V2500-A1/A5 SERIES PROPULSION SYSTEM NON-MODIFICATION SERVICE BULLETIN

This document transmits the Revision 2 of Non-Modification Service Bulletin V2500-ENG-73-0218.

V2500-ENG-73-0218

NON-MODIFICATION SERVICE BULLETIN – ENGINE FUEL AND CONTROL – INSPECTION OF FUEL
MANIFOLD FOR CHAFING BY THE EXHAUST GAS THERMOCOUPLE (EGT) HARNESS

LOCATION OF THE FUEL MANIFOLD AND CLIP POSITIONS

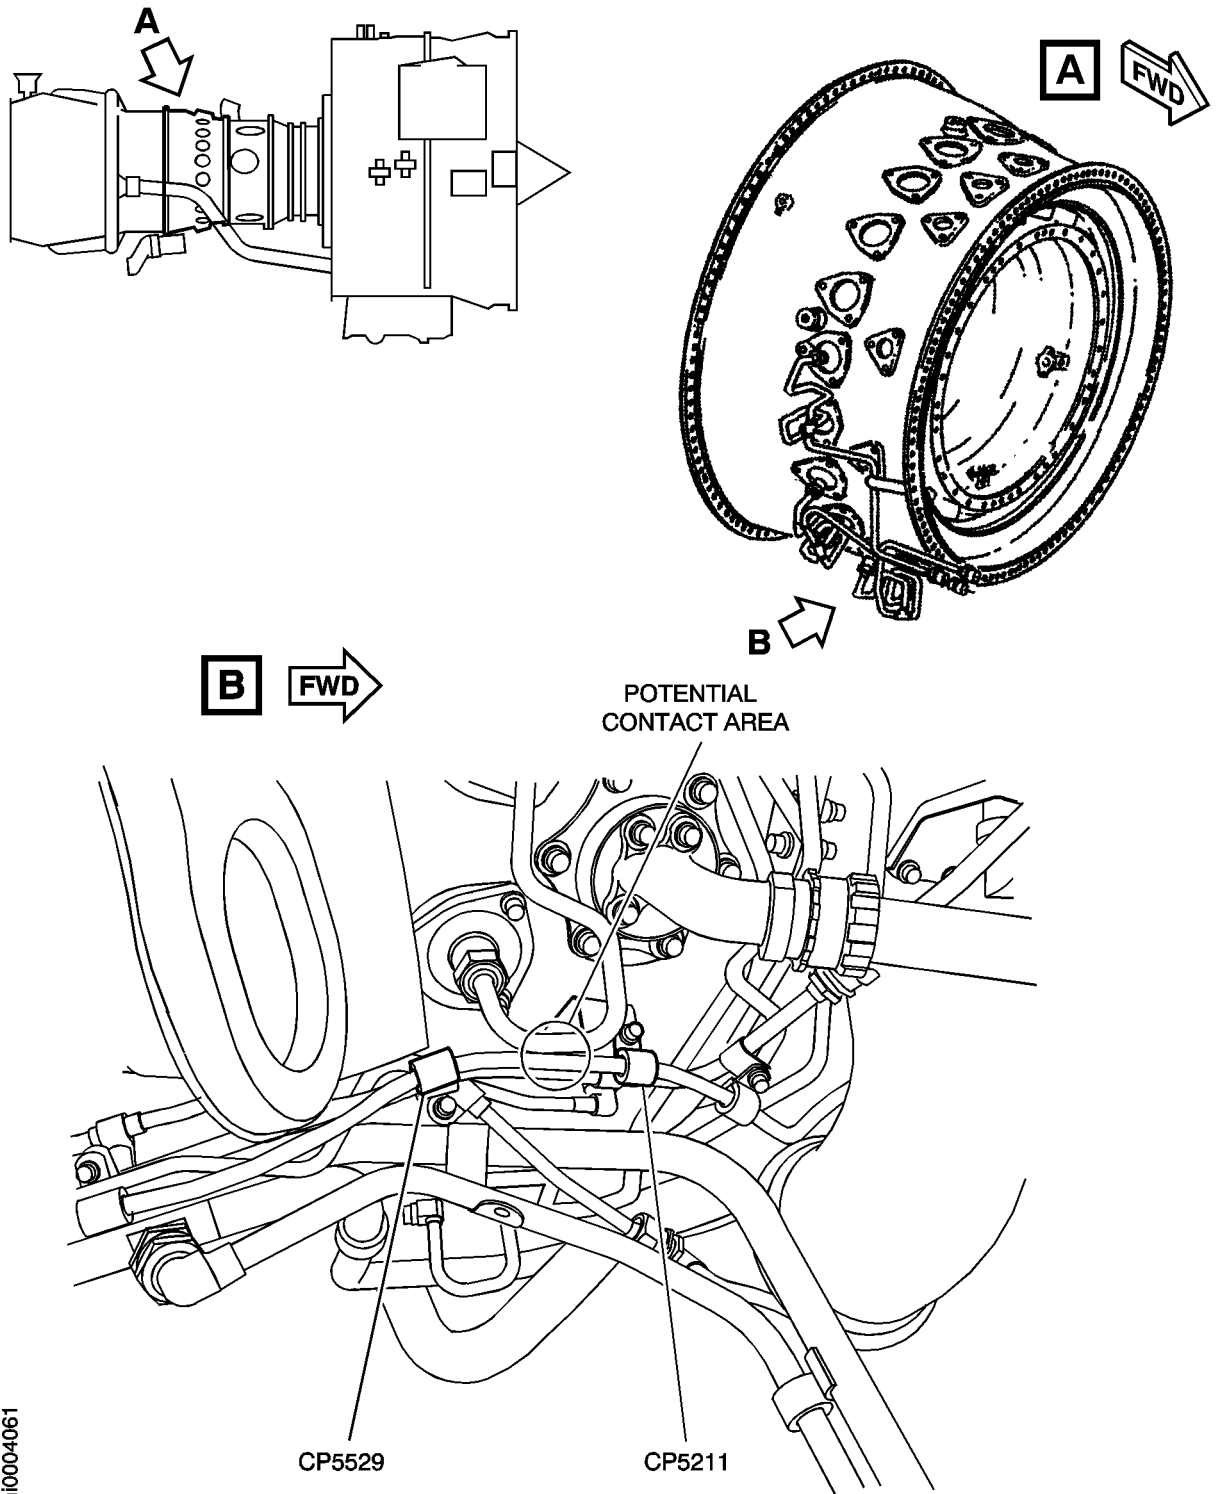
(i) A minimum clearance of 0.20 in. (5,00 mm) between the fuel manifold and EGT harness between clip positions CP5211 and CP5529 – Accept.

(i) Not more than 0.0625 in. (1,588 mm) long, 0.010 in. (0,254 mm) wide, 0.003 in. (0,076 mm) deep, with chafed areas not less than 12.0 in. (304,80 mm) apart with no sharp edges – Accept.

Orientation of potentially chafed section of fuel manifold can lie either perpendicular or parallel to adjacent EGT harness.

(ii) Less than (i) – adjust the harness and clips to make the minimum clearance 0.20 in. (5,0 mm).

R (ii) More than (i) – Replace in accordance with EM Chapter 72-00-40.
